**NOTICE
OSHTEMO CHARTER TOWNSHIP
PLANNING COMMISSION**

**THURSDAY, AUGUST 26, 2021
6:00 P.M.**

Request: Site Plan and Special Use approval to construct a multi-tenant commercial building with a drive-thru

Project Name: Hampton Plaza

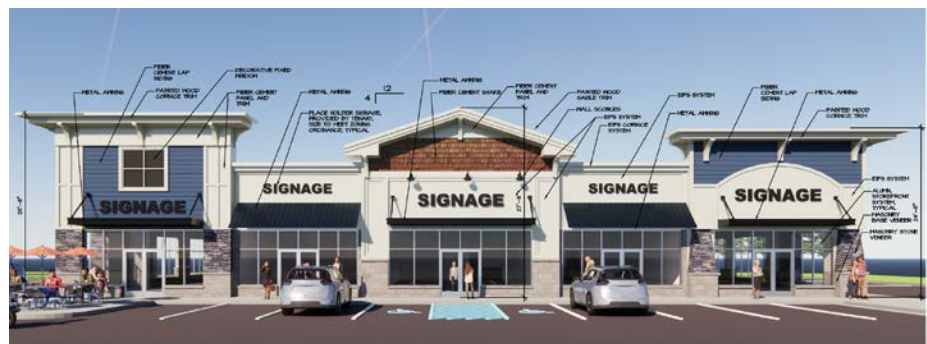
The Ordinance requires that internal parking/access aisles within a site plan be 24 feet wide for two-way traffic and 20 feet wide for one-way traffic. Overall the proposed site plan meets these requirements. However, the south most parking aisle is one-way and is shown with a width of 24 feet. The applicant requests a deviation from the Planning Commission to allow this parking aisle to be an additional 4 feet wide in order to safely accommodate emergency vehicle circulation onsite. See truck turning radius illustration to the right. The Fire Marshall has reviewed and is in support of this request.

The proposed drive-thru is on the east side of the building. Drive-thrus for non-food service establishments require a minimum of three 10 foot by 20 foot stacking spaces. Three stacking spaces, dimensions need to be added to the plan, are proposed and will be separated by a four-foot-wide raised landscape island from the general parking aisle.

4. Dimensions for the three 10' by 20' stacking spaces shall be added to the site plan prior to building permit issuance.
5. Grant the landscaping buffer deviation request to allow the landscaping buffer on the south side of the building to be smaller than the 30 feet required by code as shown on the site plan.

Plan View
Scale - 1" = 30ft

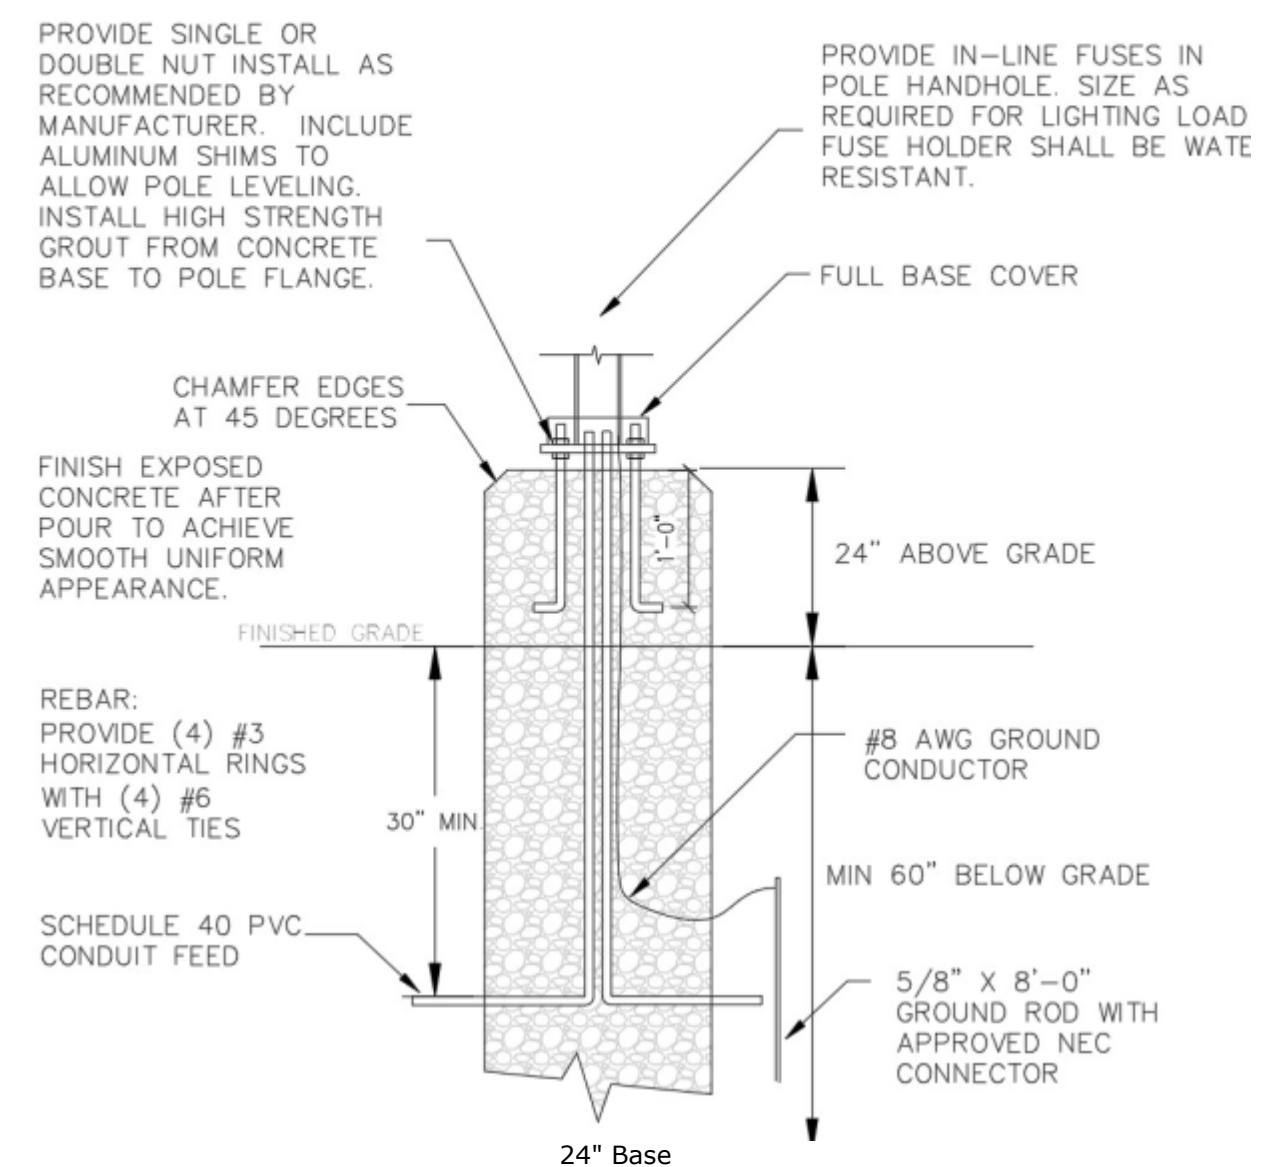
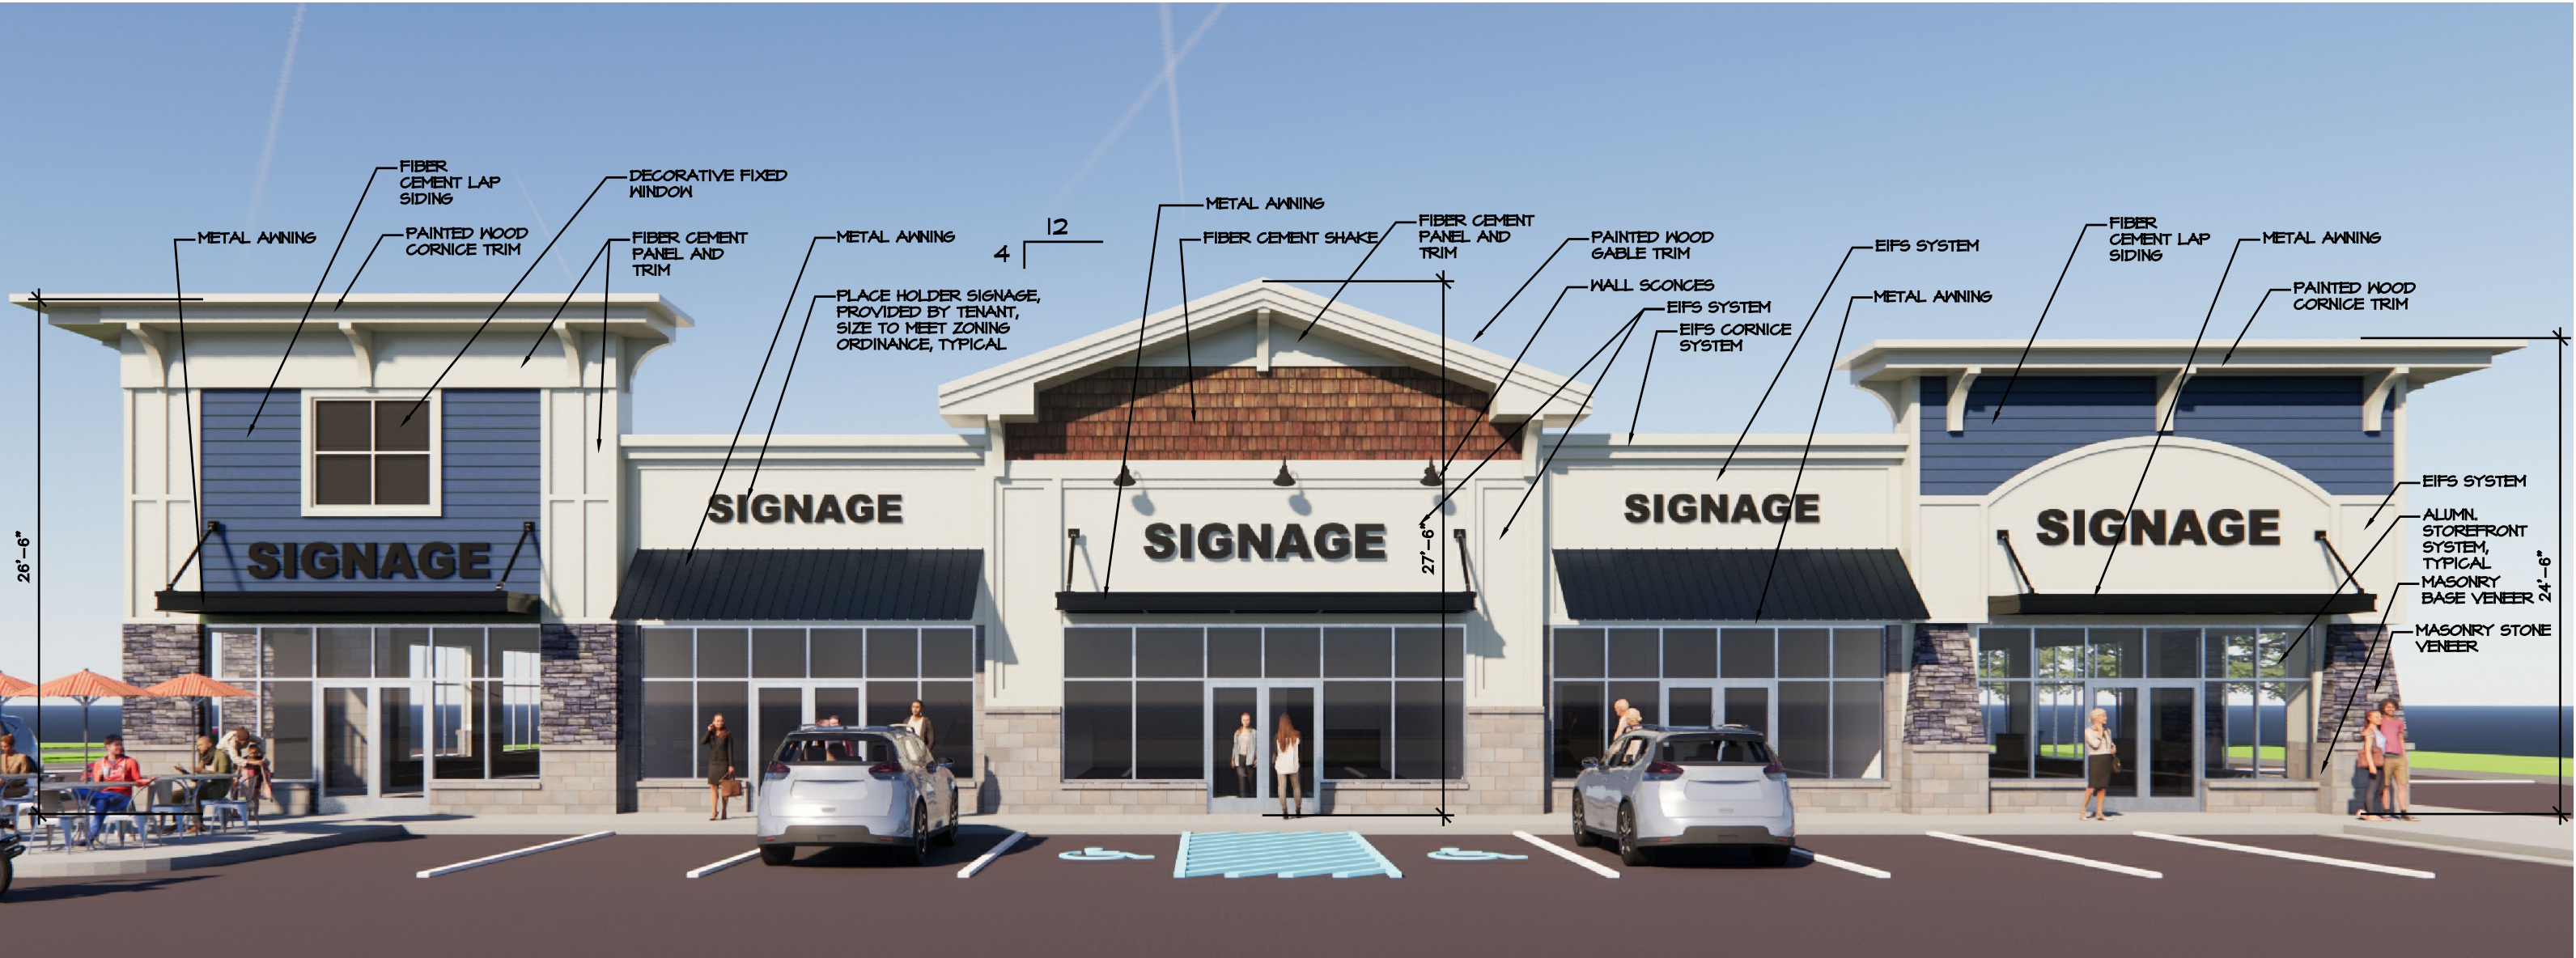
A photometric plan and lighting cut sheets have been provided. Three 20 foot tall pole mounted lights are proposed and three wall mounted lights. All proposed lights are cut off fixtures. Lighting requirements have generally been met but there are two items that need to be addressed.

1. Confirmation that the pole lights do not exceed 20,000 lumens and that the wall lights do not exceed 8,000 lumens.
2. Per the ordinance site and area lighting of nonresidential properties shall be designed such that light levels do not exceed 0.1 foot-candles at any point along the perimeter of the property adjacent to residential zoning. Some areas along the southern property line show 0.2 foot-candles. The lighting plan will need to be adjusted.

6. An updated photometric plan is provided and approved prior to building permit issuance.
7. Applications for signage are submitted and approved. It should be noted that the signage shown in the submitted plan set and architectural drawings may change as they are not part of this approval.
